## SERVICE DIRECTIVE BULLETIN

Service Directive Bulletin No. 0061

SUBJECT: Clutch Engagement Overcenter Lock Warning Light Installation

MODELS: F-28A, 280, F-28C, 280C, F-28F and 280F Helicopters

FIGURE I

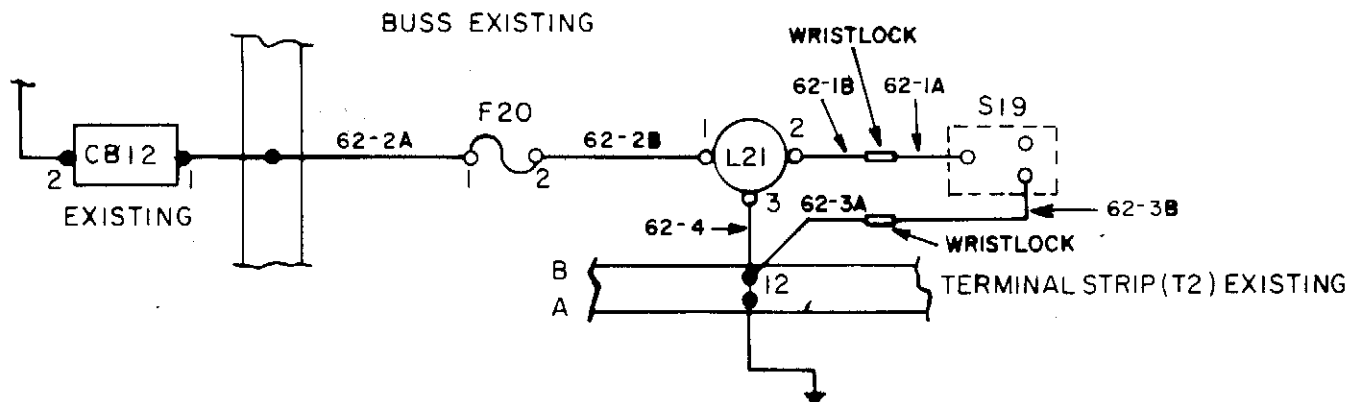
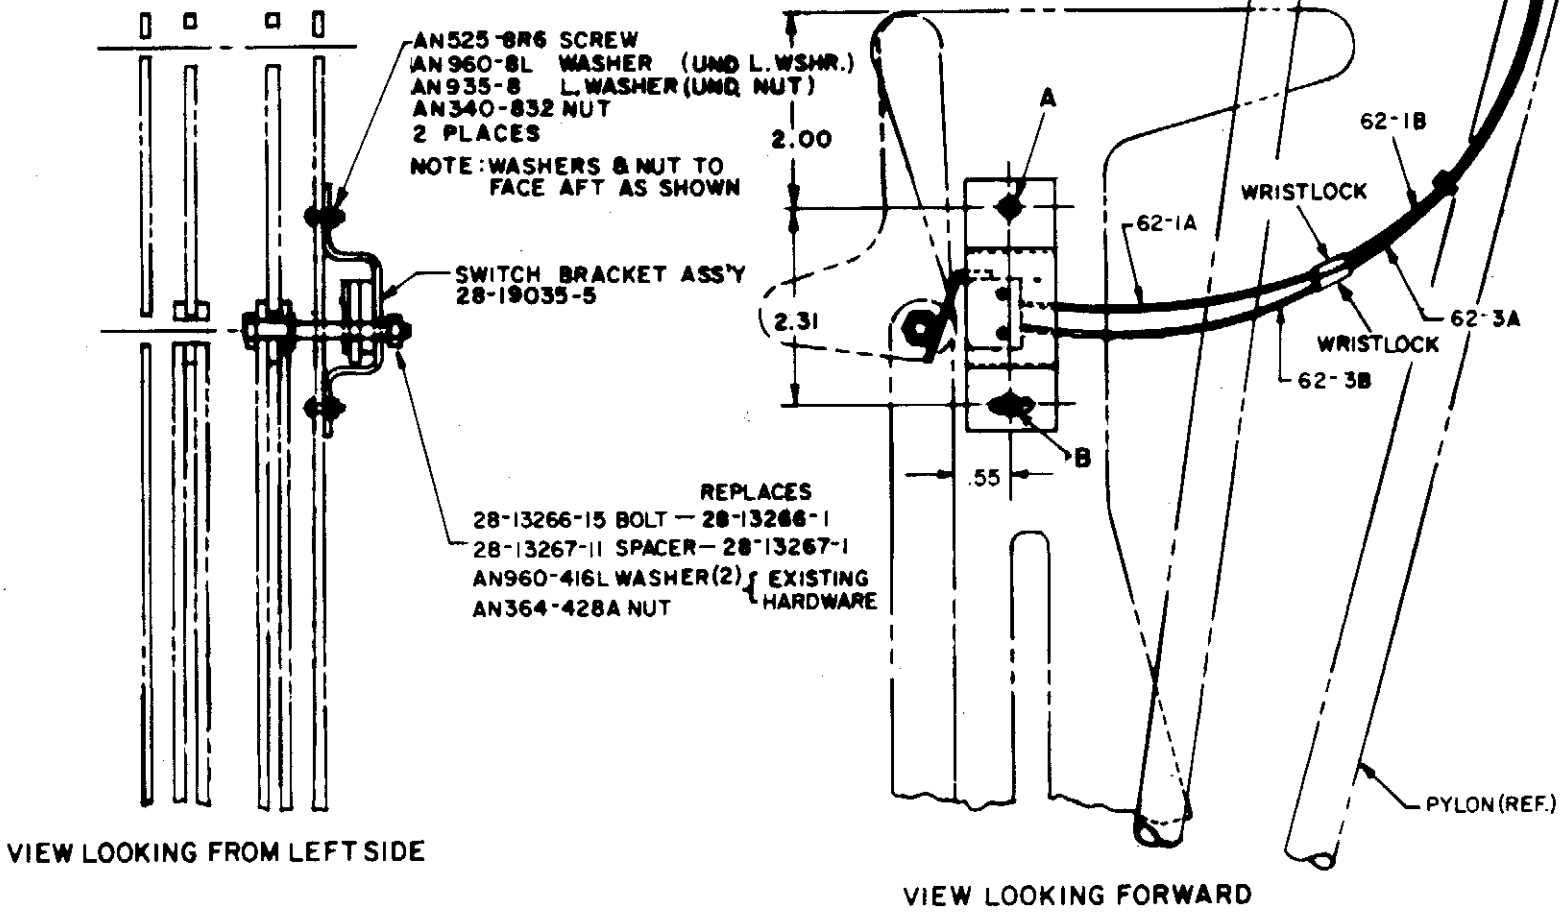
Installation can be made as follows, reference Figure 1. Change pivot hardware as noted on the aft side of assembly by removing the 28-13266-1 bolt and 28-13267-1 spacer and replacing them with a 28-13266-15 bolt and the 28-13267-11 spacer. Locate and drill two .171" diameter holes for mounting the switch bracket on the aft plate of overcenter mechanism. Install switch bracket assembly 28-19035-5 with two AN 525-8R6 screws and associated hardware as noted to the aft plate, reference Figure 1.

Reference Figure 1, connect wire number 62-1B to existing wire wrist lock on switch wire number 62-1A. Connect wire number 62-3A to existing wire wrist lock on wire number 62-3B. Slide plastic tubing over wire and wrist lock connectors. Secure with cable ties. Wiring should be checked for security with cable ties as required.

FIGURE 2

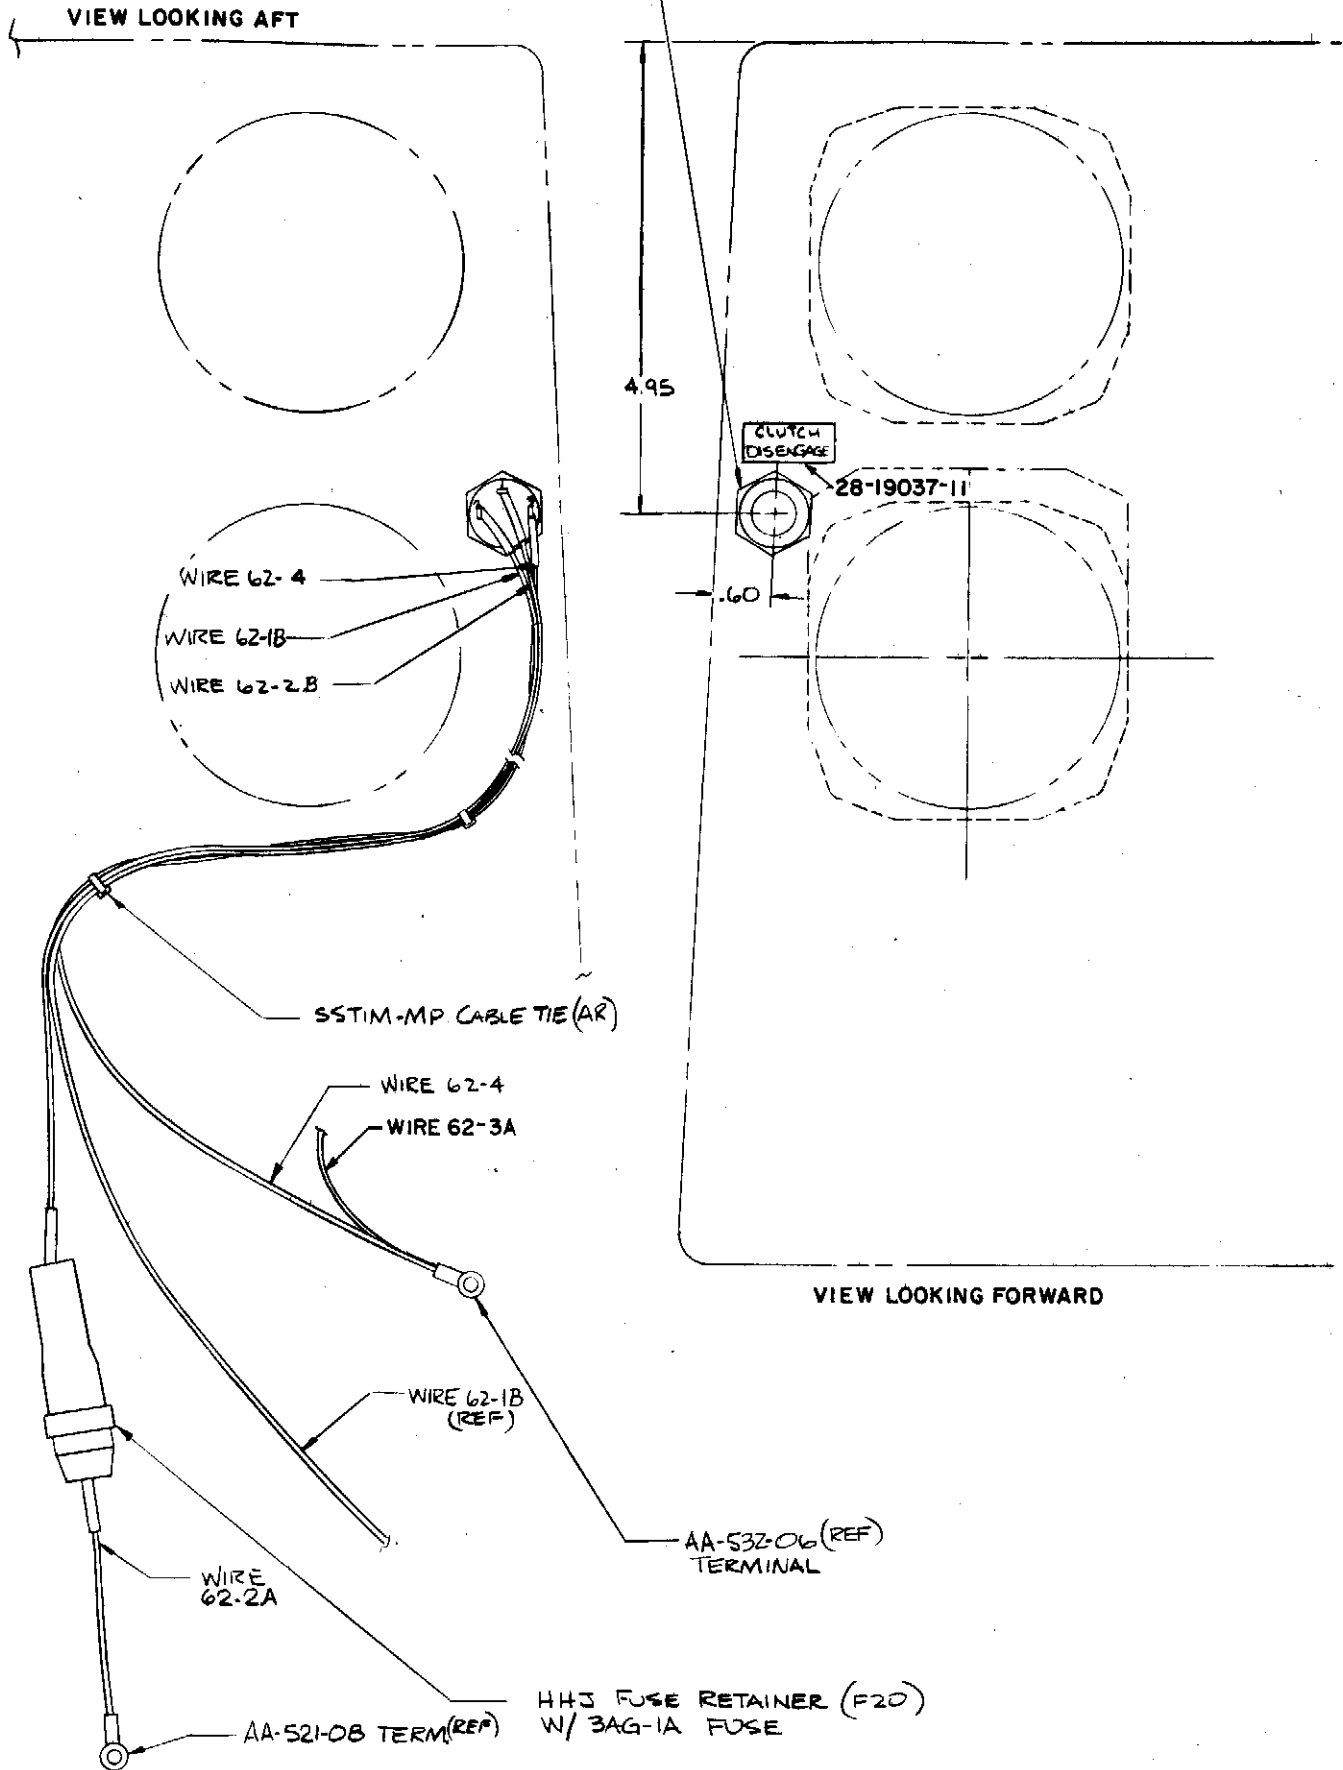
Reference Figure 2, remove instrument console shroud. Locate and punch a .640 diameter hole for warning light mounting in panel.

Install warning light (MS25331-6) into panel, install panel wiring per Figure 2, and attach placard 28-19037-11 as indicated. Attach terminal on wire number 62-2A to existing Buss at CB12 terminal #1 hot side. Attach terminal on ground wires 62-4 and 62-3A to terminal #12 on (T2) existing ground terminal at panel. Route wires number 62-1B and 62-3A through bottom cabin bay and pylon area as noted in Figure 3, and secure with cable ties as indicated.
